MEMORANDUM

PLANNING DIVISION
DEPARTMENT *of* COMMUNITY *and* NEIGHBORHOODS

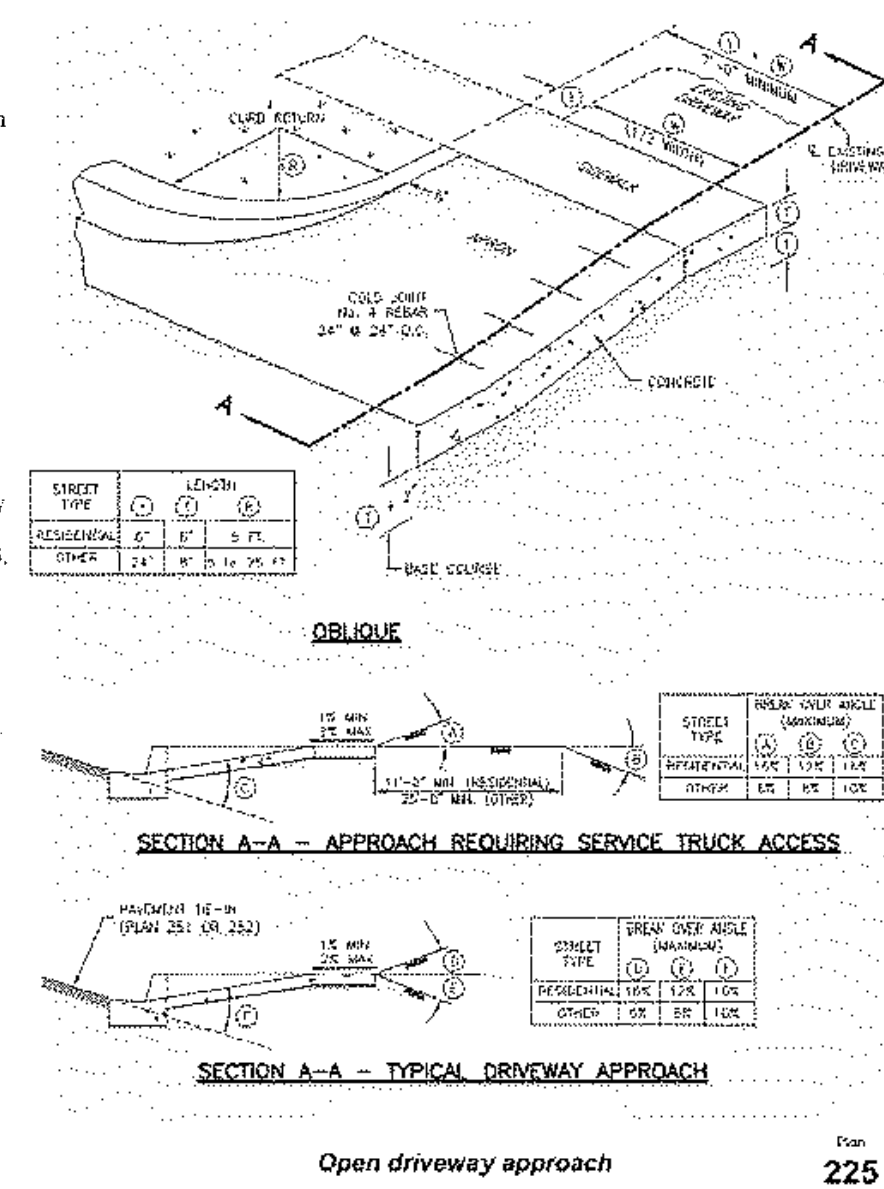
- B. Field Changes to Slope Requirements: Grades may have a 6 percent change in slope over a 11 foot wheel base run for both crest or sag vertical curves. Where heavy truck, use and fire truck access applies, or to improve design speed, design grades should be cut in half. Specific uses or site conditions may require profile design submitted for review and acceptance.
